Access Compliance Report

Public Rights-of-Way

Intersection ID: 18478	Main Street: E_INDEPENDENCE_BV	Cross Street: WALLACE RD	Location: NW
ADA ID: 3E69B61B0E2F	Ramp Type: Perp	Initial Pass/Fail: Fail	Overall Compliance: No
Codes/Mitigation Info/Possible Solution			Severity Score: 25
			Field Measurements/Component Compliance

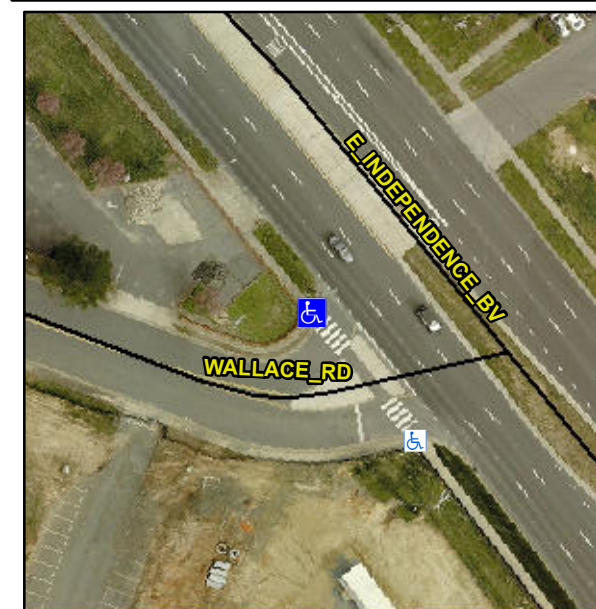
R304.2.2, R304.5.3

Remove & Replace Entire Ramp.
